## **Product Change Notice (PCN)**

PCN Number: PCN-0451149R-01

Product(s) Affected: PJ-037B

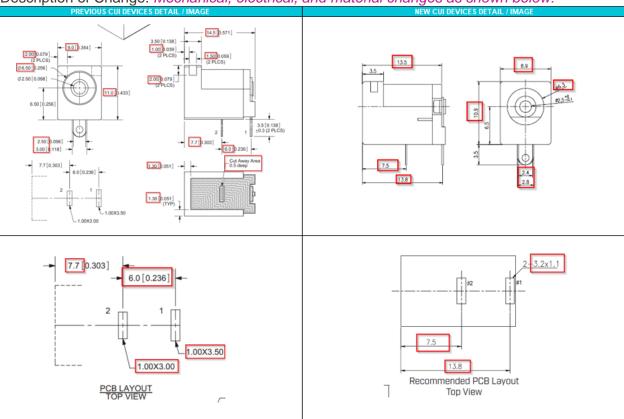
Description of Change: Mechanical, electrical, and material changes as shown below:

Insertion/Extraction force adjusted to 0.3 ~ 2.0Kg
